Report To The Honorable C.W. Bill Young,  
Sam Gibbons, And Andy Ireland  
House Of Representatives

Florida's Sunshine Skyway Bridge--  
Design And Construction Concerns

GAO/RCED-85-32  
DECEMBER 14, 1984

Figure 2

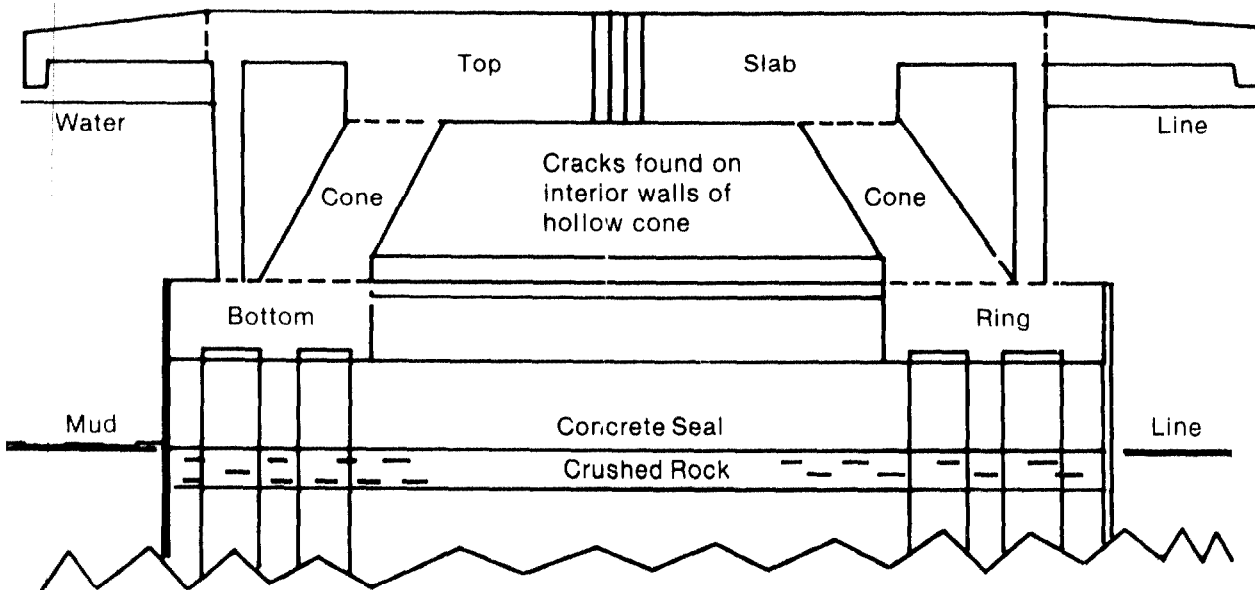
In June 1983, FDOT officials detected hairline cracks inside the hollow concrete cones of the main piers. The walls of the cones are about 8 feet thick and the interior areas of the two main support piers have about 22 hairline cracks ranging in width from .002 inches to .010 inches and in length from about 8 feet to over 15 feet. Some cracks were leaking water as of May 1984.

FDOT and FHWA inspected the cracks and said that they were shrinkage cracks. Shrinkage cracks in mass concrete, such as the main piers, occur because of stresses resulting from heat generated by the chemical reaction of cement and water, and the subsequent differential in coolings--the outside cools faster than the inside. At FDOT's request, the designer, Figg and Muller, and a consultant, Parsons, Brinckerhoff, Quade, and Douglas, inspected the cracks and concluded that they were shrinkage cracks, considered normal in large concrete pours, and would not impair the structural adequacy of the foundation. Also, FDOT sampled water from the leaking cracks, and the tests indicated that there was no rusting of the steel reinforcement bars within the concrete.

The engineers from the Corps, Bureau, and NBS agreed that shrinkage cracks can be expected in mass concrete and, at present, the cracks do not affect the structural integrity of the main piers. NBS pointed out that some of the cracks that were leaking water contained brown deposit. NBS suggested chemically analyzing the brown material alone and comparing the results with known deposits of rust to determine whether the brown material is rust. NBS also suggested that the efflorescence, or powdery deposits around the cracks, be cleaned so that any new deposits can be monitored. FDOT officials said that they had analyzed the brown deposits shortly after the cracks were identified and results showed the deposits to be largely carbonate of calcium and magnesium rather than steel rust. Also, FDOT continues to test the water leaking from the cracks, and the test results have not shown indications that rusting has occurred. The officials said that they will clean the efflorescence from the cracks so that any new deposits can be identified.

NBS reported that the long-term importance of the cracks is that they could allow seawater to come in contact with the steel reinforcing bars within the concrete and cause localized rusting of the bars. Although the reinforcing bars were epoxy-coated to deter rust, according to the Bureau and NBS, it is probable that there are breaks in the coating of some bars which occurred when the concrete was poured around the reinforcing bars. FDOT officials said that they were considering a number of possible ways of addressing the cracks. However, they do not plan to implement a solution until after the bridge deck is placed on the piers. FHWA officials said that they will analyze FDOT's repair method after FDOT decides how to address the cracks. One solution proposed by an FDOT consultant was to seal the inside cracks to a depth of one and one-quarter inches. After repairing the cracks, FDOT plans to fill the hollow cones with fresh water to offset the pressure from the seawater outside the cones.

At our request, the federal engineers commented on the proposal to seal the inside cracks. They said that surface sealing of the cracks on the inside to a depth of one and one-quarter inches would not eliminate the possibility of corrosion of the steel reinforcing bars. NBS suggested investigating the feasibility of sealing the cracks for their entire depth and that careful consideration be given to the repair method to be used. FDOT

officials said that they would consider the federal engineers' comments and they were open to further suggestions.

Figure 3

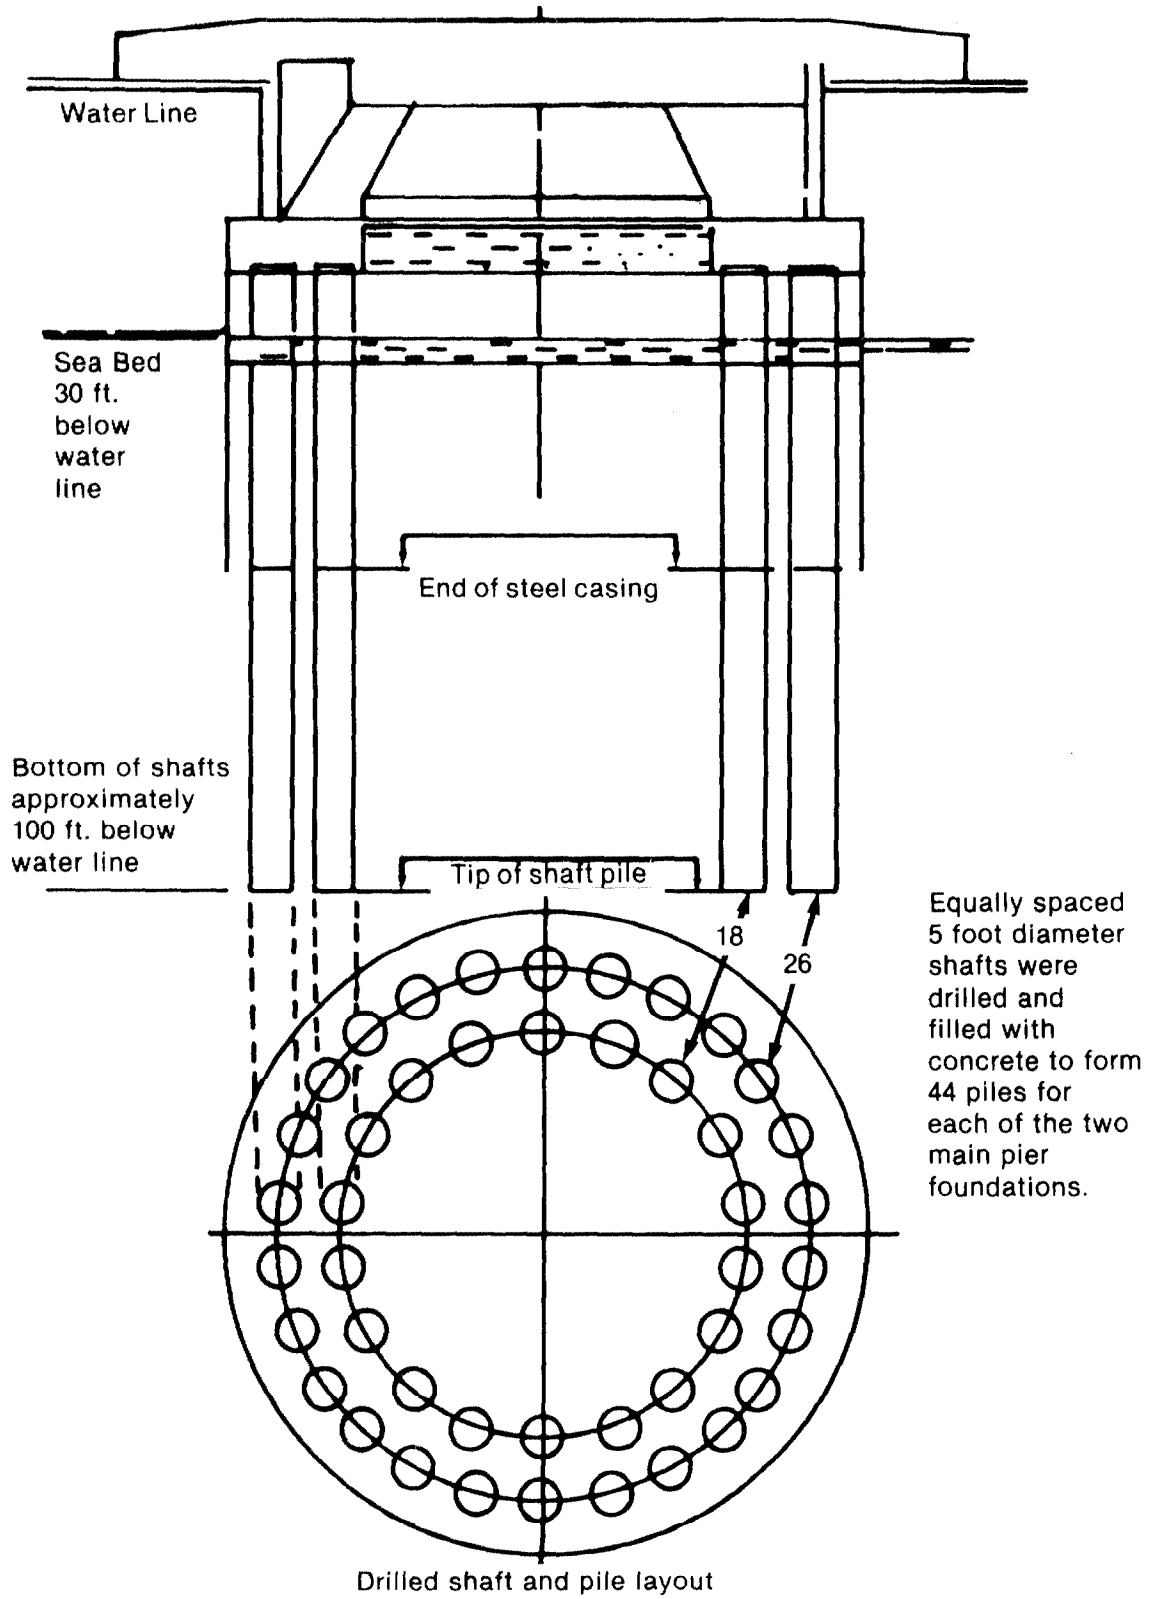
During construction of the south main pier, the contractor had difficulty obtaining core borings from the bottom of the shafts. The shafts were drilled to specified depths in the seabed, core borings taken, and then the concrete piles were poured into the shafts. (See fig. 3 on p. 18 showing the foundation shafts.) The core borings were used to determine the composition of the soil at the tip of the shafts and verify prior geotechnical work. The contractor was unsuccessful in obtaining core borings from the first two shafts of the south main pier. FDOT officials directed the contractor to modify the core boring equipment. The

shaft drilling and concrete pouring continued while the equipment was being modified. On the 15th shaft, the contractor, with modified equipment, obtained a boring that indicated the subsoil was not as expected. However, the boring had been infiltrated with water and broken up when removed from the core boring equipment. FDOT requested the assistance of its geotechnical consultant who observed two more drillings and then recommended drilling the remaining 27 shafts 6 to 7 feet deeper than originally planned. FDOT adopted the recommendation as a conservative measure based on safety.
